dsPIC33EPXXXGP50X, dsPIC33EPXXXMC20X/50X and PIC24EPXXXGP/MC20X Family Silicon Errata and Data Sheet Clarification

The dsPIC33EPXXXGP50X, dsPIC33EPXXXMC20X/50X and PIC24EPXXXGP/MC20X family devices that you have received conform functionally to the current Device Data Sheet (DS70000657H), except for the anomalies described in this document.

FIGURE 1: TIMING DIAGRAMS FOR CENTER-ALIGNED AND EDGE-ALIGNED MODES

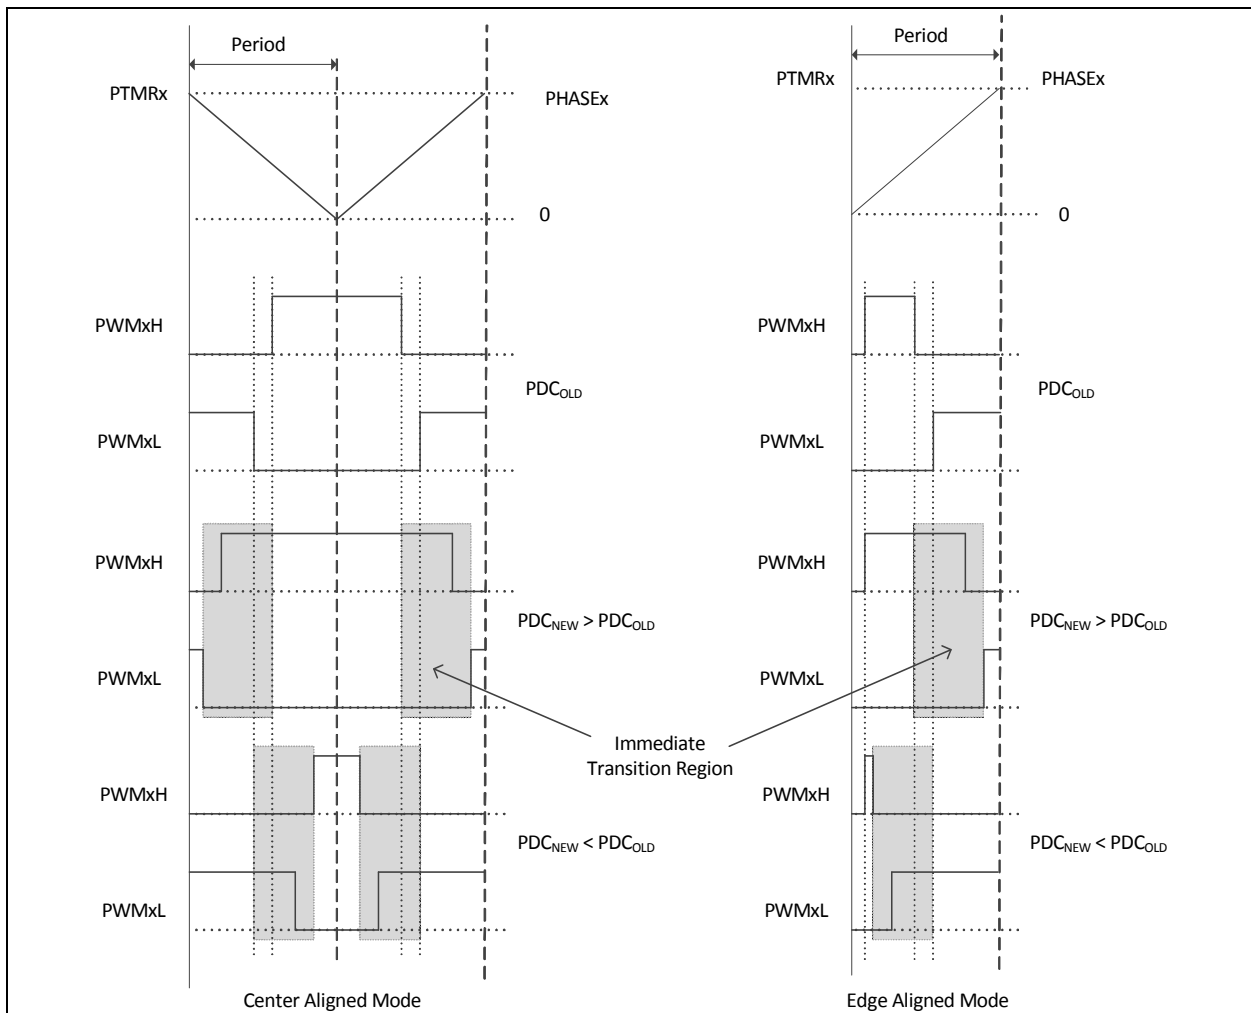
The PWM generator may not assert dead time on the edges of transitions. This has been observed when all of the following conditions are present:

- The PWM generator is configured to operate in Complementary mode with Independent Time Base (ITB) or master time base;
- Immediate update is enabled; and
- The value in the PDC register is updated in such a manner that the PWMxH and PWMxL outputs make an immediate transition.

The current duty cycle, PDC_{OLD}, newly calculated duty cycle, PDC_{NEW}, and the point at which a write to the Duty Cycle register occurs within the PWM

time base, will determine if the PWMxH and PWMxL outputs make an immediate transition. PWMxH and PWMxL outputs make an immediate transition if the Duty Cycle register is written with a new value, PDC_{NEW}, at a point of time when the PWM time base is counting a value that is in between PDC_{NEW} and PDC_{OLD}. Additionally, writing to the Duty Cycle register, close to the instant of time where dead time is being applied, may result in a reduced dead time effective on the PWMxH and PWMxL transition edges.

In [Figure 1](#), if the duty cycle write occurred in the shaded box, then PWMxH and PWMxL will make an immediate transition without dead time.

However, in most applications the duty cycle update timing can be controlled using the TRIGx trigger, or Special Event Trigger, such that the above mentioned conditions are avoided altogether.

FIGURE 2: PWM TIMING DIAGRAM

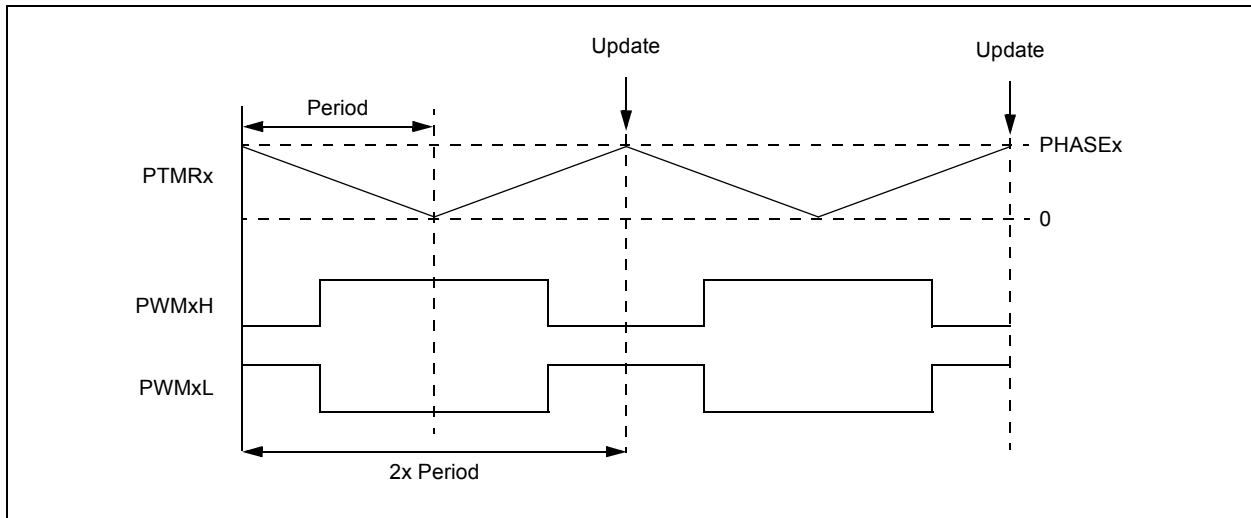
In Center-Aligned mode, updates to active MDC/PDCx/ALTDTRx/PHASEx registers occur only once every two PWM periods; that is, when the PWM timer matches the PHASEx register. In other words, the double update feature is not available. Figure 2 illustrates this relationship.

FIGURE 3: CORRECT AND INCORRECT POSITION COUNT CAPTURES

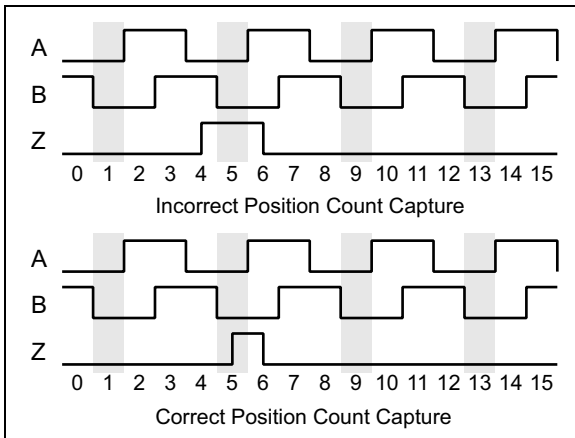
When index count position capture is being used (QEIXOC.QCAPEN = 1), the position count may be one more or one less than the correct value, depending on the direction of the count.

This is only observed when the leading edge of the index pulse occurs prior to the leading edge of the index match event. When the index pulse starts after the leading edge of the index match event, the position count is captured correctly.

Figure 3 shows how this occurs. In these cases, Encoder Signals A, B and (index) Z are shown, with the module being configured for index match when A and B are '0'. The effects of a correct and incorrect capture are shown side by side (shaded area indicates the index match event); the position count is shown along the bottom.

For encoder signals with timing that ensures the index pulse always starts prior to the start of the index match event (i.e., encoders with a non-gated index pulse), measure the direction of the encoder motion. If the encoder is counting up, add one to the captured position count; if the encoder is counting down, subtract one from the captured position count.

For encoder signals where the index pulse leading edge approximately coincides with the start of the index match event (i.e., encoders with a gated index pulse), a small delay can be added to the index pulse, for instance, by using a simple R-C filter.

FIGURE 4: PWM GENERATOR TIMING DIAGRAM

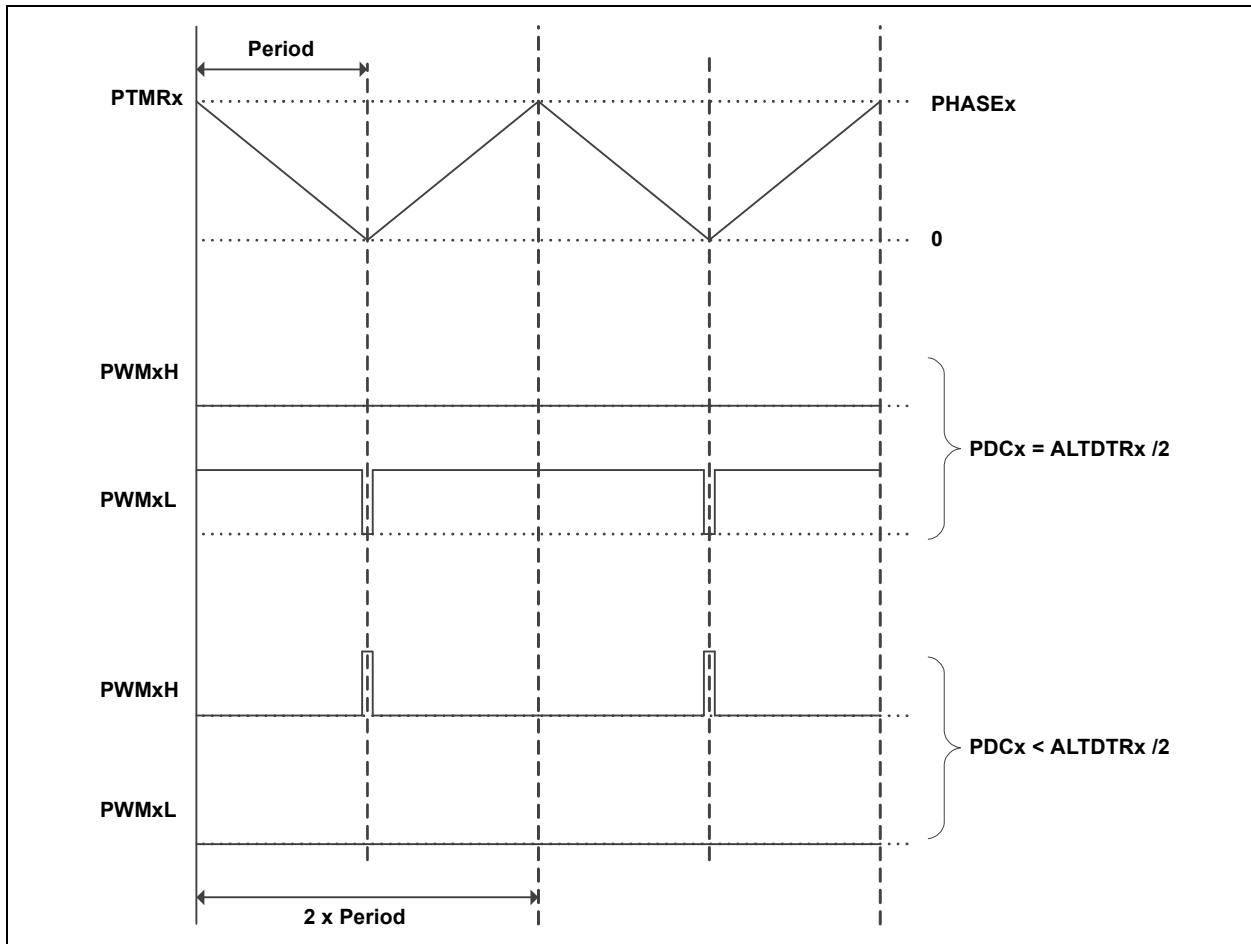
In Center-Aligned Complementary mode with Independent Time Base, if the value in the PDCx register is less than one-half the value in the ALTDTRx register, the PWM generator will force the PWMxL to low, and on the PWMxH, generate pulses of width less than twice the dead time, as shown in Figure 4.

FIGURE 5: ILLUSTRATION OF 1 T_{osc} GLITCH WHEN PWM OVERRIDE IS TURNED OFF

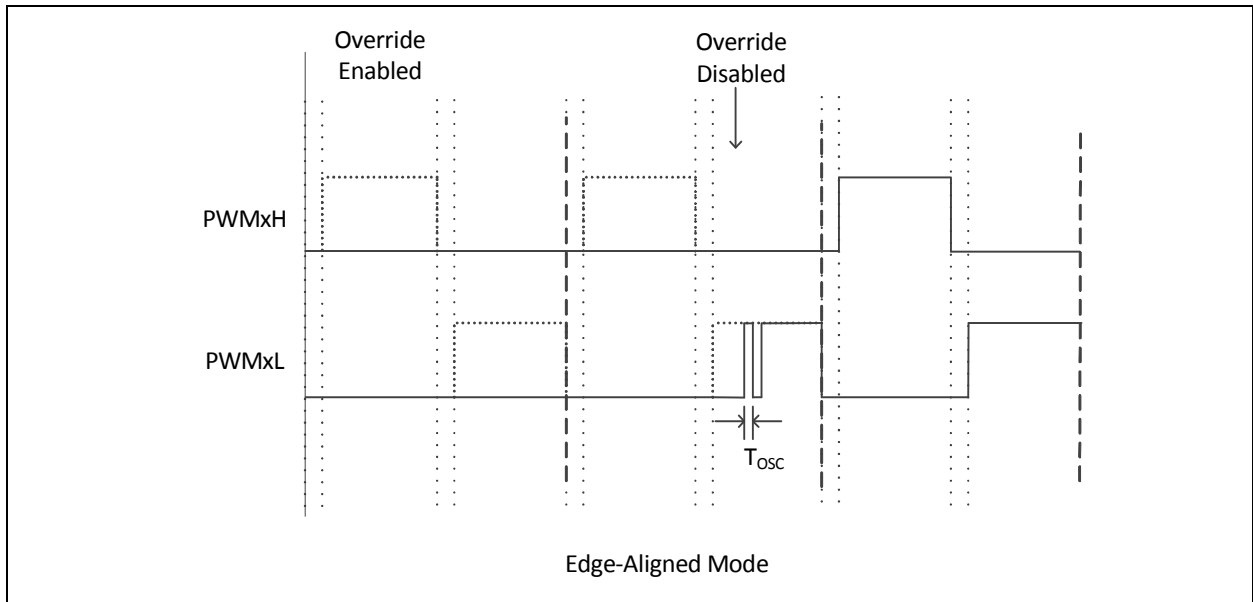
In Complementary mode after the PWMx module is enabled (PTEN = 1), if the PWM override is turned off, a 1 T_{osc} glitch will be present on the rising edge of either PWMxH or PWMxL, whichever occurs first, as shown in Figure 5. The glitch will be present on PWMxH/PWMxL every time the override state is changed from enabled to disabled. The width of this glitch is equal to 1 T_{osc} when PCLKDIV<2:0> = 000; increasing the PWM input clock prescaler setting will increase the width of the glitch accordingly.

FIGURE 6:

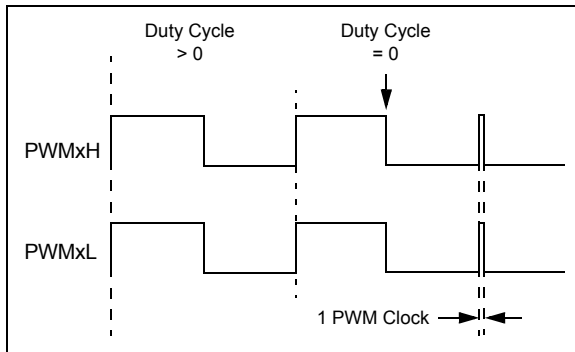
In certain output modes, the PWMx module produces a pulse glitch of one PWM clock in width (Figure 6). This has been observed only when all of the following are true:

- Either Redundant or Push-Pull Output mode is selected (IOCONx<11:10> = 10 or 01);
- Immediate Update is disabled (PWMCONx<0> = 0); and
- The value of the current Duty Cycle register (either the PDCx or MDC register, as determined by PWMCONx<8>) is updated to zero from any non-zero value.

The pulse glitch has been observed to occur at the beginning of the following PWM boundary period.

FIGURE 7:

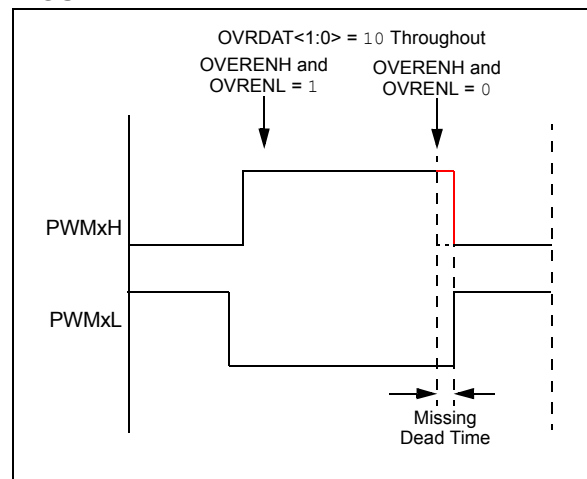
- Output override synchronization is configured to occur on the CPU clock boundary (IOCONx<0> = 0);
- Both PWMxH and PWMxL overrides are enabled prior to the event (OVRENH and OVRENL are both '1'), and
- Both overrides are disabled (OVRENH and OVRENL are both '0') at the instant the dead time should be asserted (Figure 7).

This has been observed in both Center-Aligned and Edge-Aligned modes.

FIGURE 8:

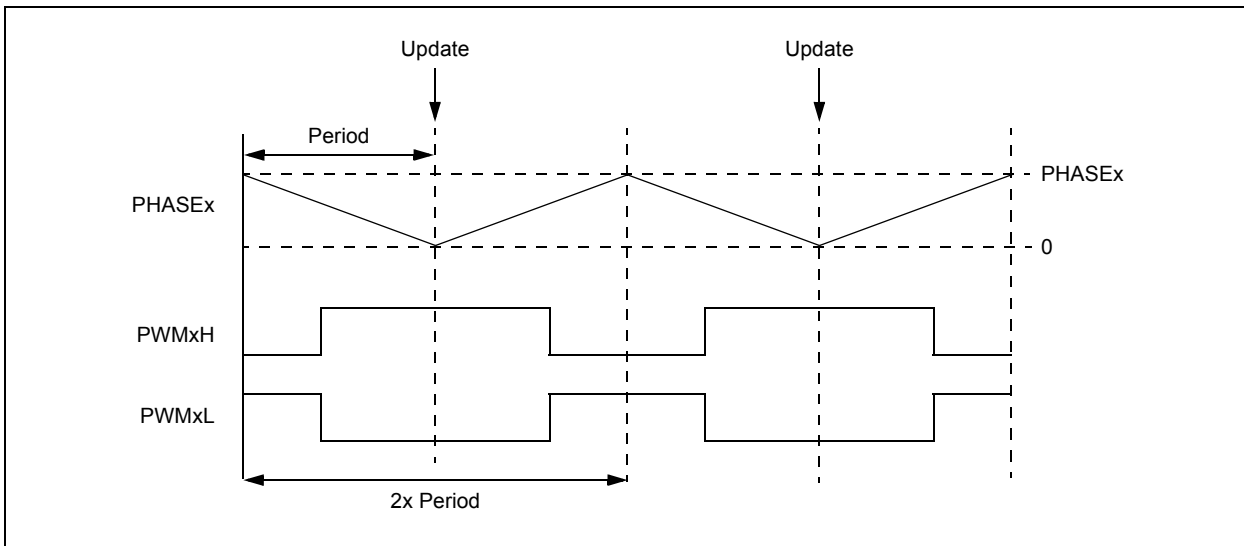
In Center-Aligned Complementary mode with Independent Time Base, updates to the PHASEx register take effect in the middle of a center-aligned PWM cycle, as shown in Figure 8. This occurs only when the Immediate Update feature is disabled (IUE = 0). If Immediate Update is enabled (IUE = 1), the PHASEx register updates will take effect immediately.

FIGURE 32-10: TYPICAL LPRC FREQUENCY @ VDD = 3.3V

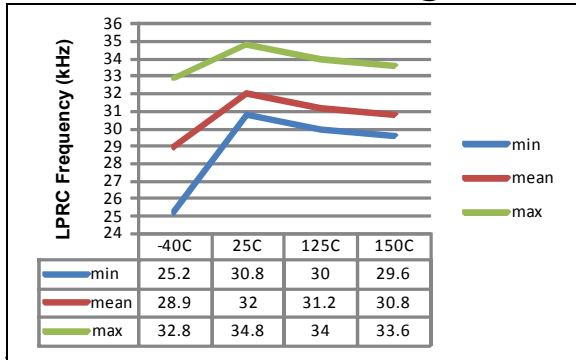
The typical LPRC frequency plot over temperature at VDD = 3.3V has been corrected as shown in Figure 32-10 below.

FIGURE 25-1: OP AMP/COMPARATOR x MODULE BLOCK DIAGRAM (MODULES 1, 2 AND 3)

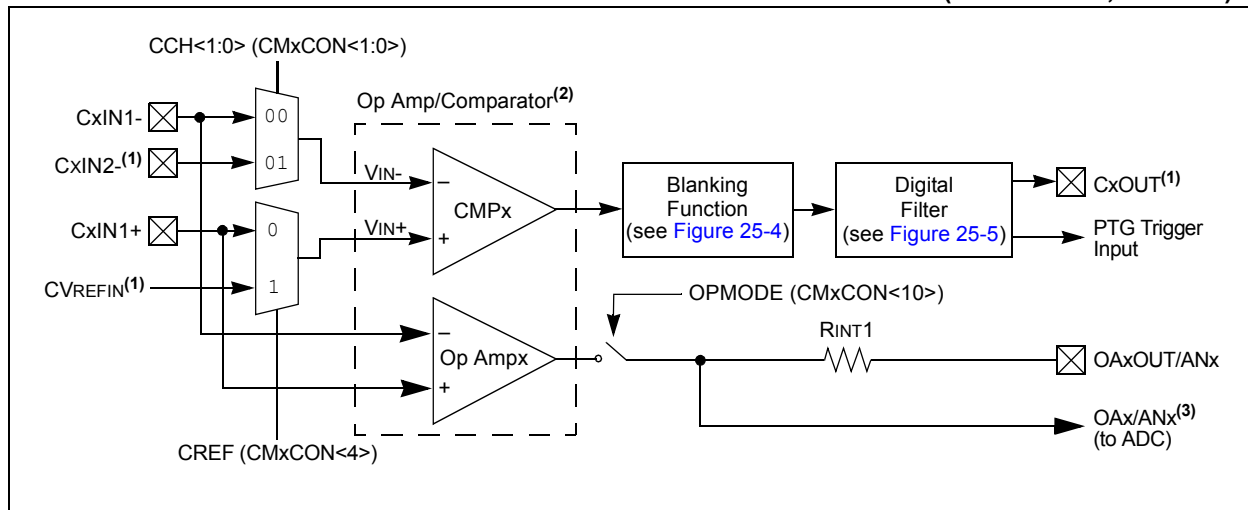
Figure 25-1 (shown below) is corrected to show that the op amp in these modules obtains its inverting and non-inverting inputs directly from the CxIN1-/1+ pins. The operation of the actual module is unchanged. (Footnotes in the original are unchanged, but are removed here for clarity.)
